NO. 79/Z/4

Recall Campaign Bulletin

RECALL CAMPAIGN A457
HEADLAMP MOTOR

1975-78 TR7

FIGURE 3.

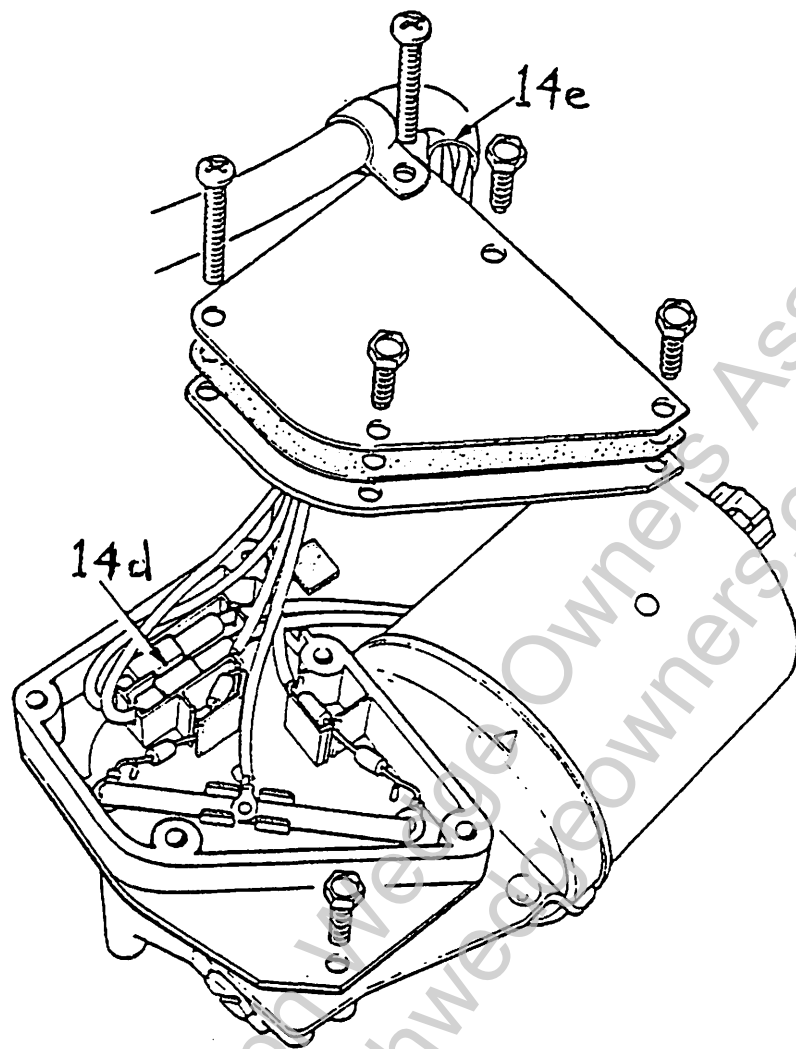
On units where the cable sleeve is clamped by a plastic harness clip to the switch box cover (see Figure 3) and the cables terminate in two single and one triple connector, no action is required.

The remaining 5 leads are then placed side by side on top of the small foam pad followed by the large foam pad, the liner and the original top cover. The original screws are then used to secure the top plate and harness clip mounted adjacent to the cable entry position. (See Figure Number 3).

FIGURE 4.

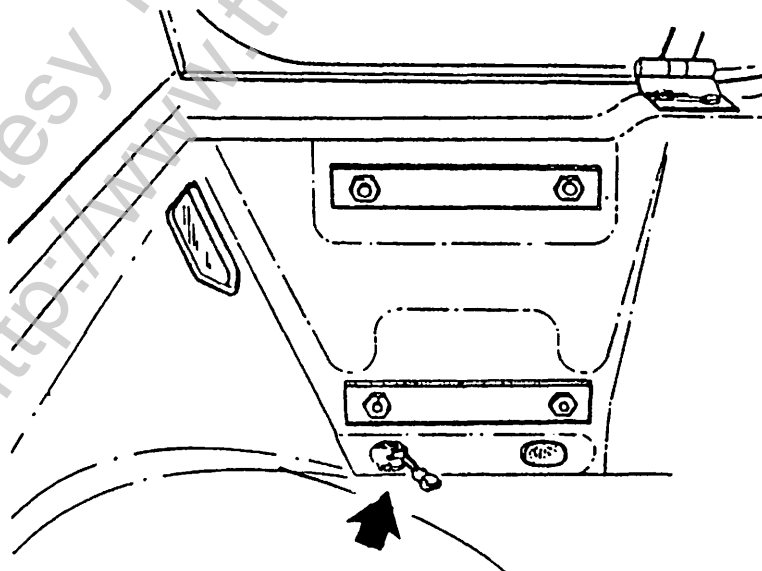
Where possible withdraw the main harness through the grommet in the closing panel into the engine bay. (See Figure 4).

FIGURE 5.

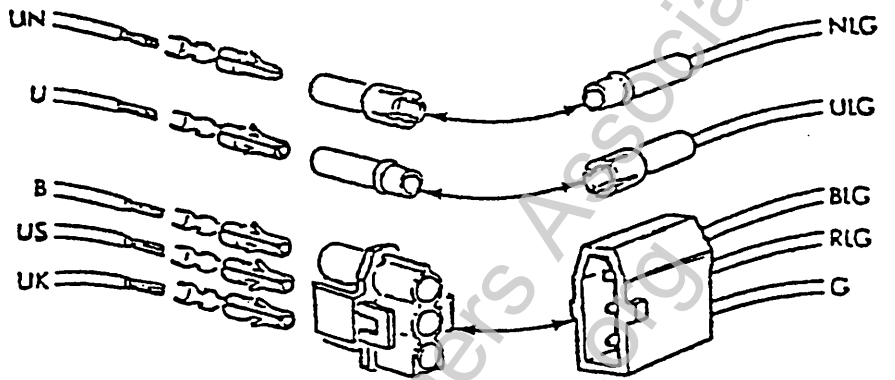
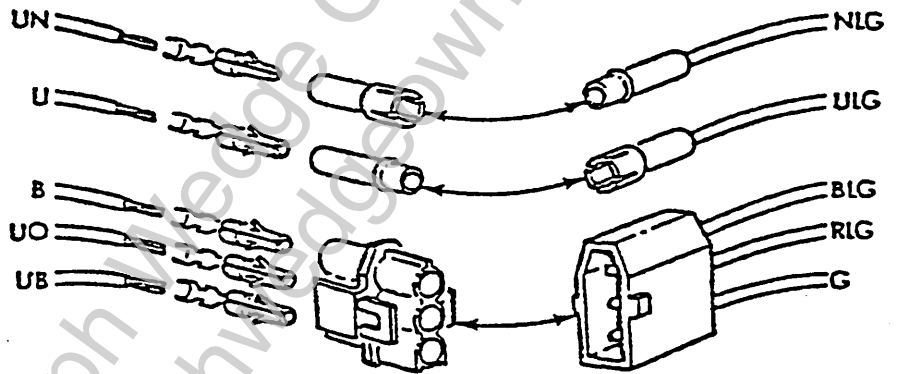
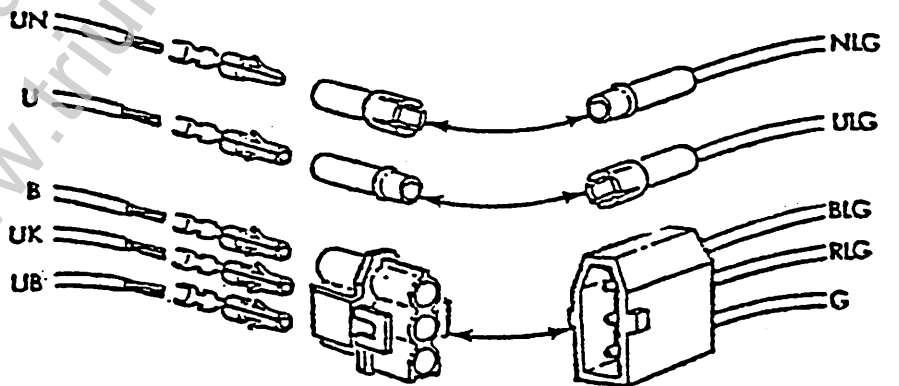
Discard the original harness 5 pin connector blocks by cutting the cables as close to the blocks as possible. Strip back the cable insulation approximately 1/4" (6mm) on each lead and solder 3mm pins, and then fit sockets. (Kit Part Number AEU 1485 K). (See Figure 5 for alternative color code wiring connections).
